Some slides from IRENG07
preparation meeting with
questions to crab-cavity group

August 27, 2007
Andrei Seryi

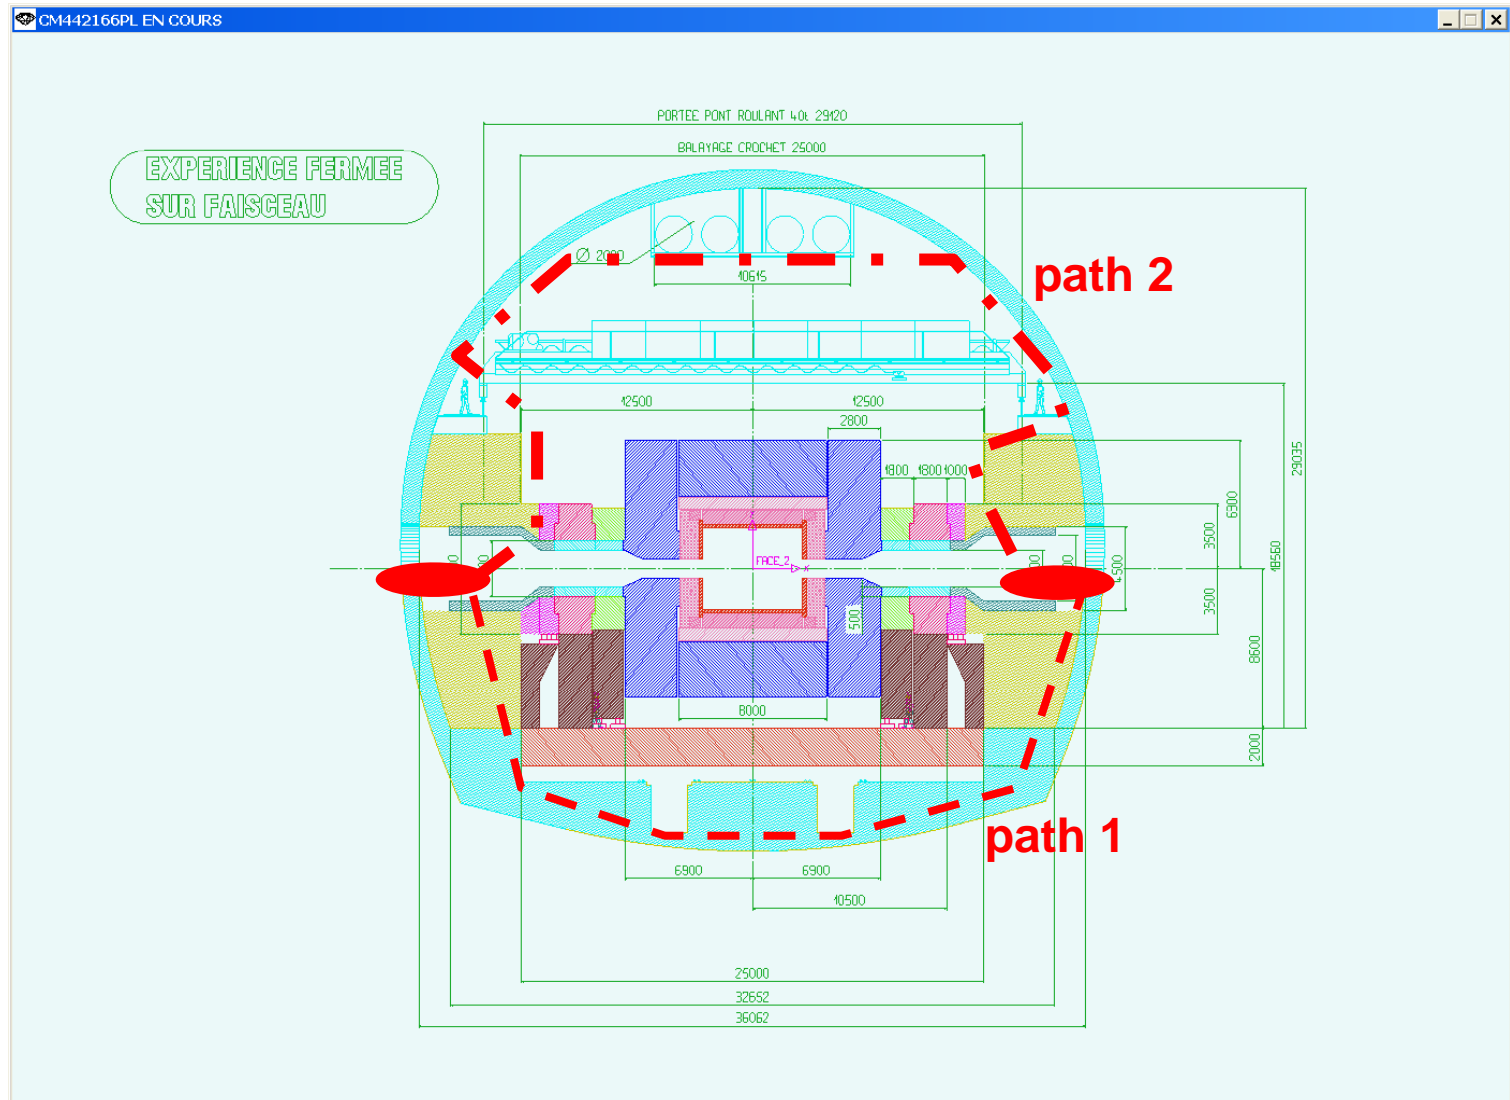
Assuming that “survey gallery” does not exist or blocked due to radiation safety reasons, where should we place the klystrons? Is location (1) good for that?

If (2) can be made accessible, what are the advantages?

Connections between cavities: some cables, 10cm OD coax, fibers?

Path to have low vibration, T stabilized conduit, decent radiation conditions?

Path 1 easier from vibration issues?

Path 3: around the hall. Is it possible?

path 3

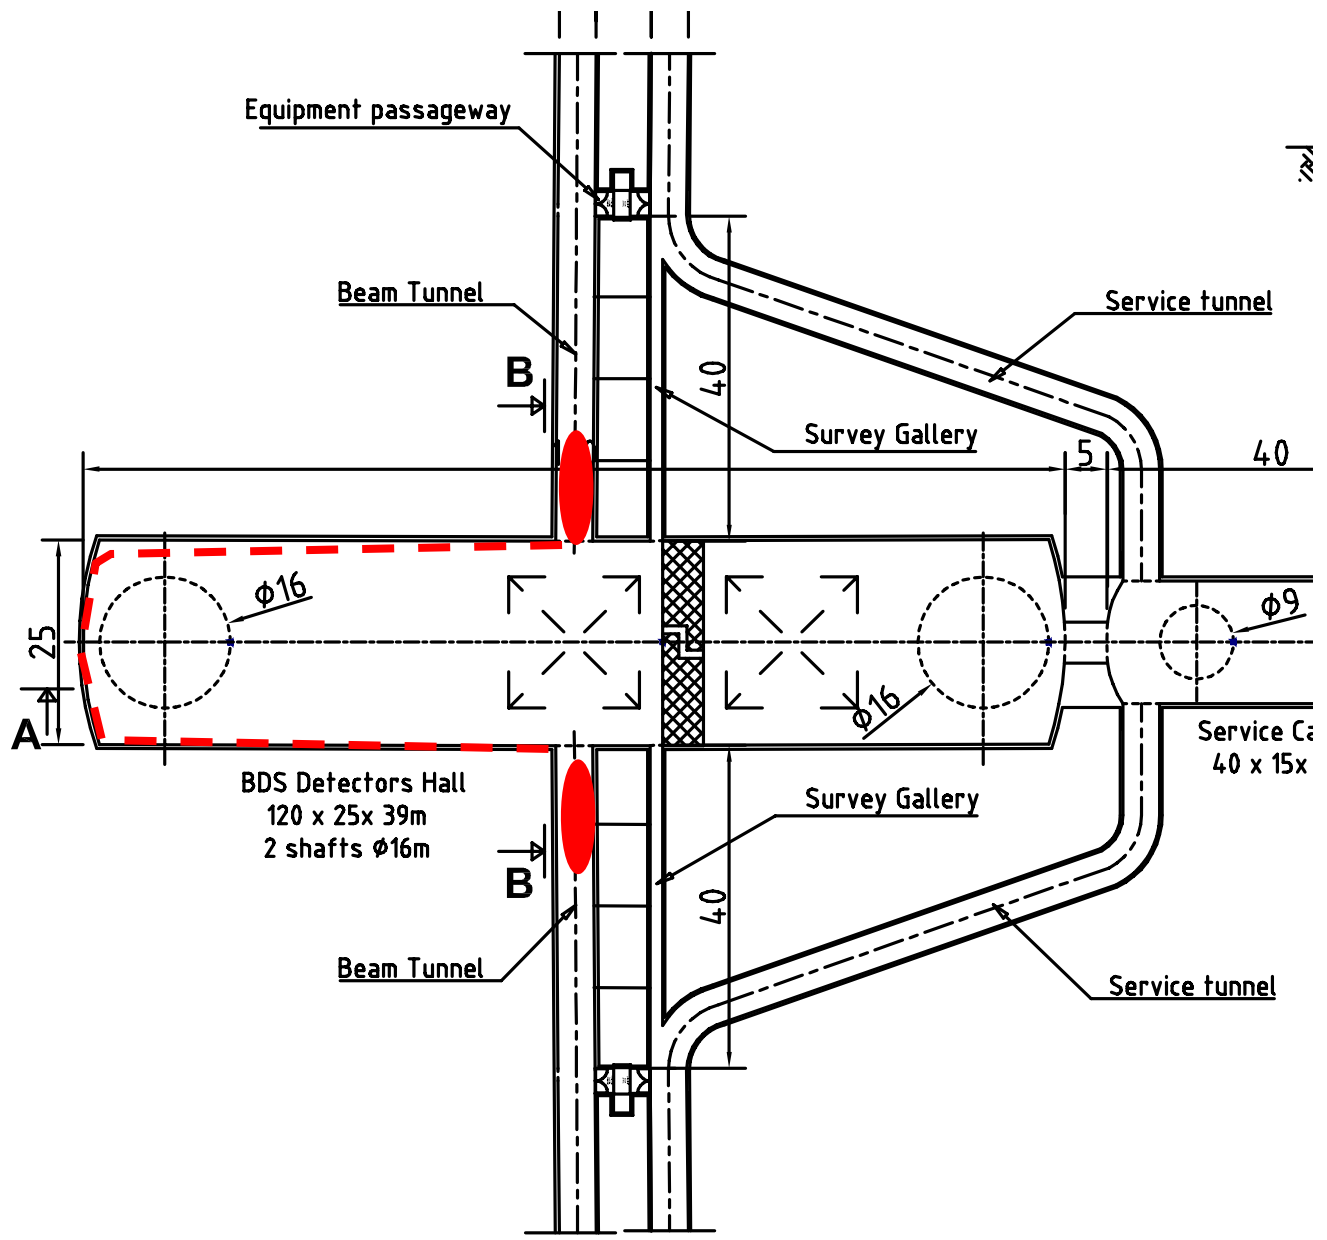
Detector solenoid field in the region of the cavity could be ~50Gs level.

Could it be shielded out?
